From: [Jacobsen, James](#)
To: [Detterman, Karel, Env. Health](#)
Cc: [Jacobsen, Brittani](#); [Edwards, Carl](#)
Subject: RE: Fuel Leak Case R0307 - Global ID T06019734265 - ARCO #0402/Parking Lot, 1450 Fruitvale Avenue, Oakland, CA 94601
Date: Monday, September 19, 2016 12:15:17 PM
Attachments: [image007.png](#)
[image005.png](#)
[image006.png](#)
[CA 402 Broadbent - Figure 1. Site Map.pdf](#)

Subject: Fuel Leak Case R0307 - Global ID T06019734265 - ARCO #0402/Parking Lot, 1450 Fruitvale Avenue, Oakland, CA 94601

Thank you for submitting the July 29, 2016 *Soil and Groundwater Investigation Report* prepared and submitted on your behalf by Broadbent and Associates, Inc. (Broadbent). Alameda County Department of Environmental Health (ACDEH) has evaluated the data and recommendations presented in the *Soil and Groundwater Investigation Report* (Report) in conjunction with the case

Site Map with Former and
Current Site Features

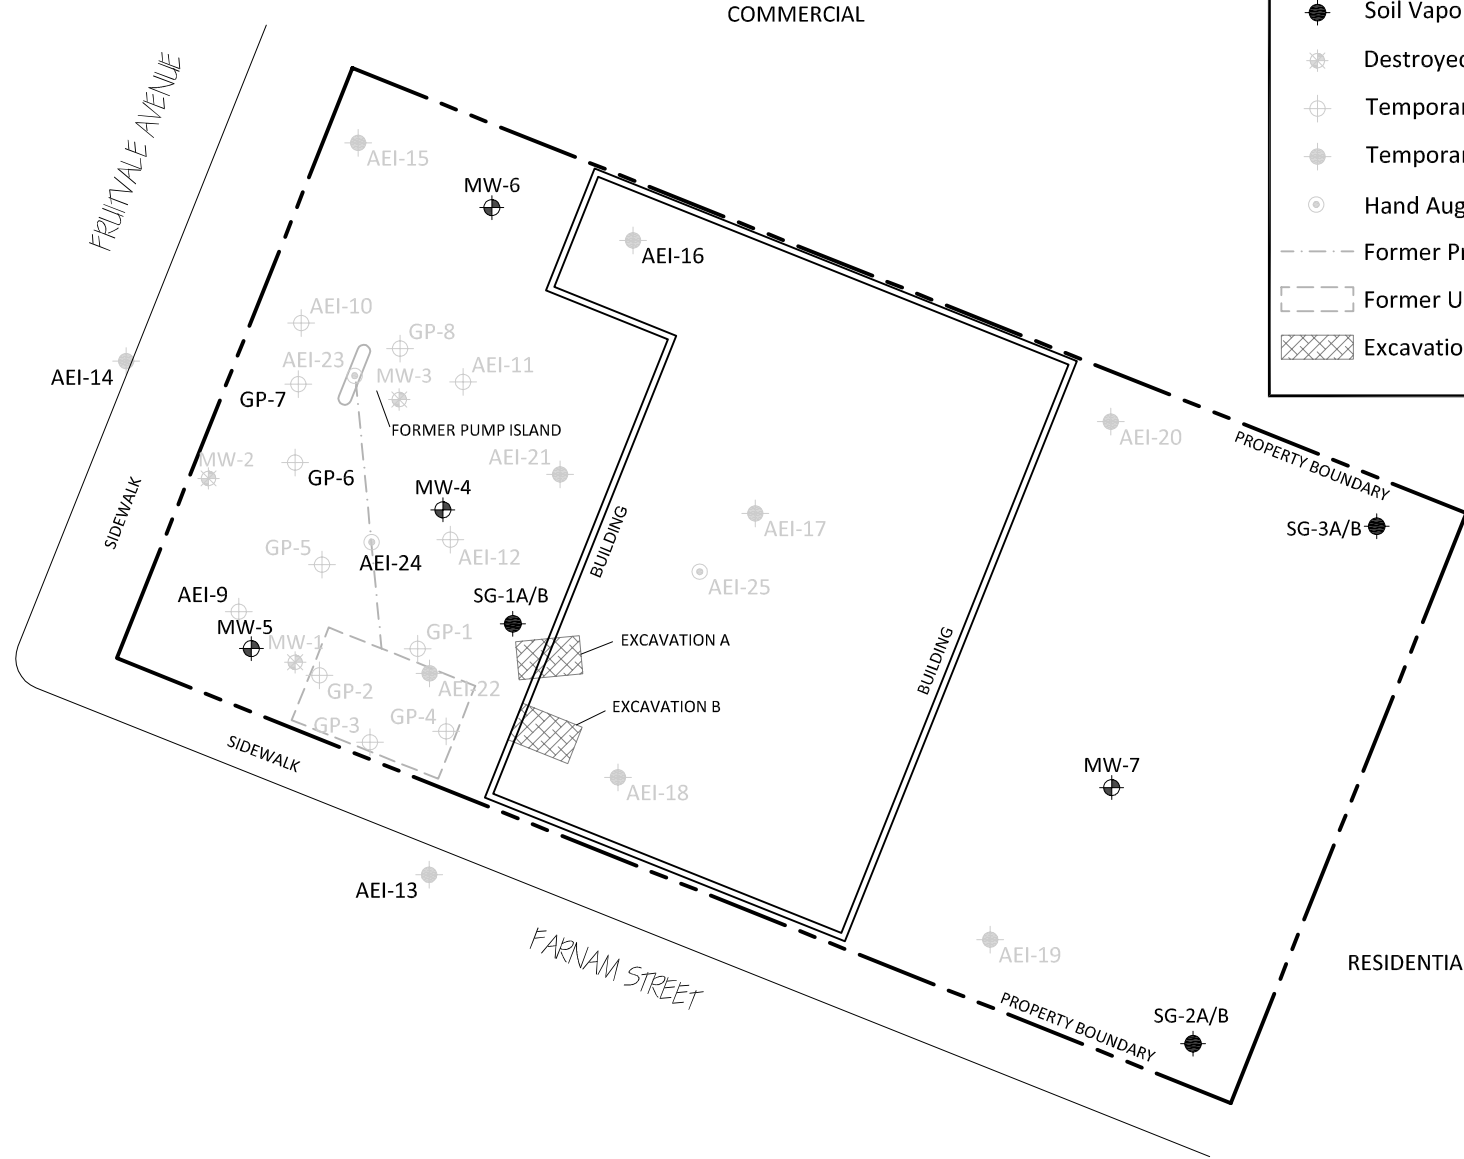
From what I can determine from Google Street View, this is a 3-story commercial building. The location of the elevator appears to exist in the location of AEI-16 (a temporary boring completed in 2002). Please refer to Broadbent's site map (attached). The elevator appears to be attached to the building and accessible by an outdoor causeway.

files and the State Water Resources Control Board's (SWRCBs) Low Threat Underground Storage Tank Case Closure Policy (LTCP). Sufficient data has not been presented to enable the successful evaluation of the LTCP's Vapor Intrusion to Indoor Air (VI/IA) Media Specific Criteria through the elevator shaft of the three-story building. Specifically, no data was presented concerning the location or depth of the elevator shaft as requested in ACDEH's May 9, 2016 directive letter.

Under Scenario 1, a bioattenuation zone of 10 feet beneath the bottom of the elevator shaft must be present due to the benzene concentration of 130 micrograms per liter (ug/L) in MW-4 in June 2016. Based on groundwater level data in MW-4 and MW-7, located on either sides of the building, groundwater beneath the building can be assumed to rise as high as 10.63 feet. In order to satisfy the VI/IA criteria, the elevator shaft cannot extend greater than 1 foot below grade.

Under Scenario 2, soil gas measurements must be collected at a depth of 5 feet beneath the bottom of the elevator shaft. Soil gas samples collected at the site were advance to a maximum depth of 5 to 5.5 feet. This data is representative for at-grade construction and not for subsurface features such as elevators. The depth of the elevator must be determined in order to evaluate the appropriate methodologies and criteria to satisfy the LTCP VI/IA.

1. Please submit a figure indicating the location of the elevator and any subsurface features such as stair wells and a cross section indicating the depth of the elevator shaft and stair wells. Also, please identify if the elevator has a sump and the depth of the sump.
2. Please monitor and sample the four site monitoring wells to evaluate the increasing trend in MW-4.

In reviewing the data associated with AEI-16, it appears that the soil concentrations at 10' and 19' below ground surface are less than the residential direct exposure ESLs (Regional Water Board – S.F. Bay Environmental Screening Levels) and the 100 mg/kg GRO criteria as outlined in Scenario 3 of the LTCP. Also, the groundwater concentrations of benzene at AEI-16 are below the CA MCLs and the 100 ug/L benzene criteria as outlined in Scenario 3 of the LTCP. Though the incumbent did not incorporate this data into a comprehensive data set, as requested in the LUFT manual, the data was included as an attachment to the March 11, 2016 CSM and Case Closure Request (screen shot below). A second line of evidence indicating that a dissolved benzene plume is not in the area of the elevator is permanent monitoring well (MW-6); located within 20-feet. A review of the groundwater analytical data associated with MW-6 indicates the concentrations of BTEX/MTBE are also below the CA MCLs and Scenario 3 of the LTCP.

Based on these details, I believe Scenario 3 of the LTCP has been met and further assessment of the Vapor Intrusion pathway is not necessary.

Finally, per the LTCP and as documented in the March 11, 2016 CSM and Case Closure Request, the areal extent of constituents-of-concern appears stable for the groundwater pathway and meets criteria 2 of the LTCP. The plume length is approximately 100-feet (please refer to Figure 7 of the March 11, 2016 CSM and Case Closure Request). Based on these details, further assessment of the groundwater pathway is not necessary; therefore, submittal of work plan or technical report is not warranted.
